RE: SSD 7603; Nos. 24-28 John Street and Nos. 4, 6, 8, 10, 12, 14, 16, 18, 20, 22, 24, 26 and 28 Board Street, Nos. 3, 5, 7, 11, 13, 15 and 17 Ann Street, Lidcombe 2141 NSW

I object to part of the abovementioned proposal, namely the above-ground multistorey carpark that will be constructed on Board and Ann Street. I have not included any objection to the proposed hotel in this submission. Internet hyperlinks have been included for your convenience.

Figure 1

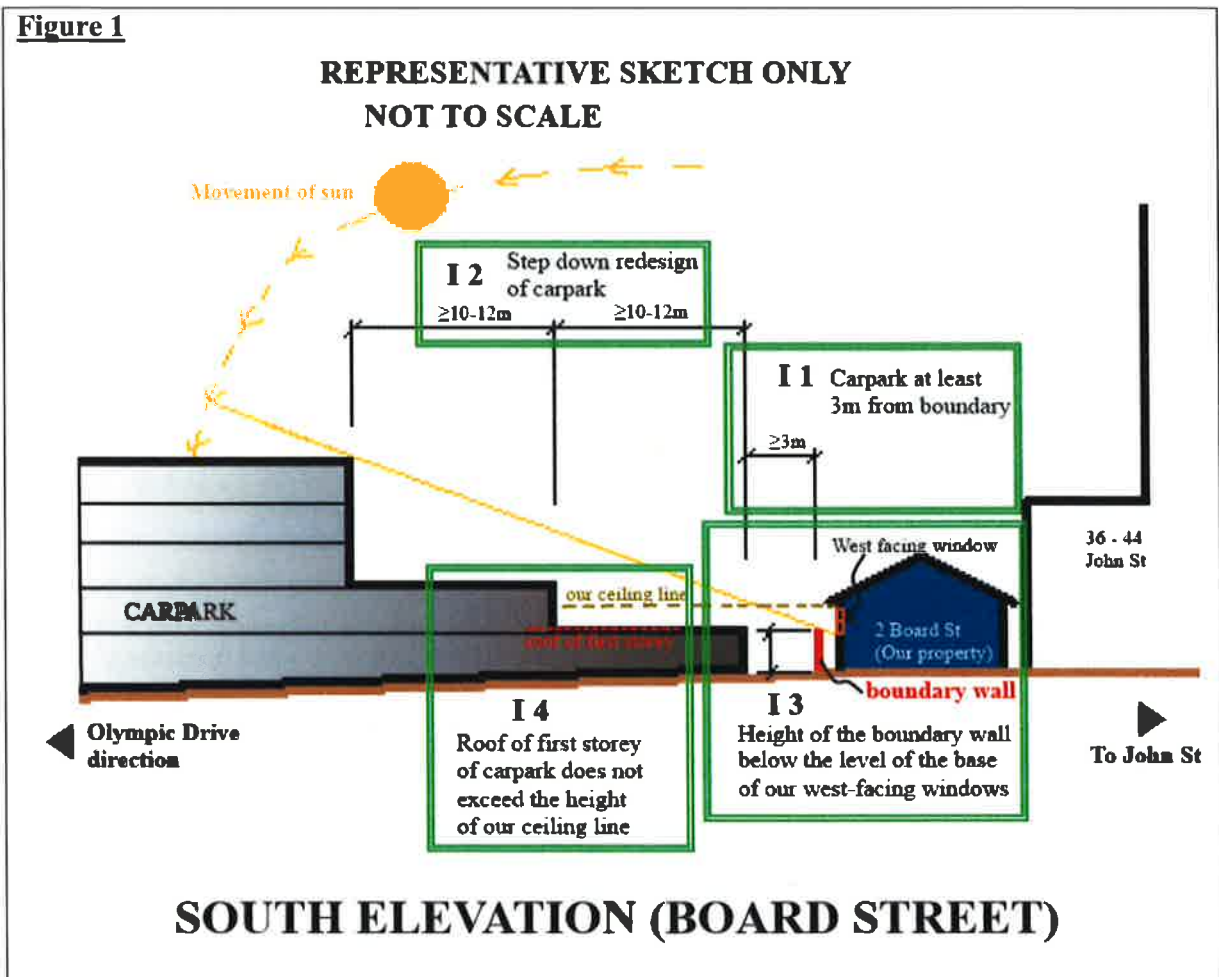
For the improvements mentioned below, please see Figure 1 for a representative view. I feel that all these changes are necessary to reduce overshadowing and to increase my solar access.

- I 1 Instead of building so close to the boundary, setback the proposed multilevel carpark **at least 3 metres** from our common boundary.
- I 2 Instead of the current design with no stepping down, change the design of the carpark such that there is a **step-down**, with the higher storeys being closer to Olympic Drive than those closer to my property. In Figure 1, I have shown a situation where I would increase my solar access. The eastern wall of the first storey could be spaced at least 10 – 12 metres from the eastern wall of the second storey. The eastern wall of the second storey could be spaced at least 10 – 12 metres from the eastern wall of the remainder of the storeys.

- I 3 Instead of the proposed boundary wall being built much higher than my single storey dwelling, build the boundary wall at or below the level of the *base* of the west-facing windows on my property.

- I 4 Ensure that the roof of the first storey of the carpark is no higher than the level of our ceiling of the west-facing rooms on my property.
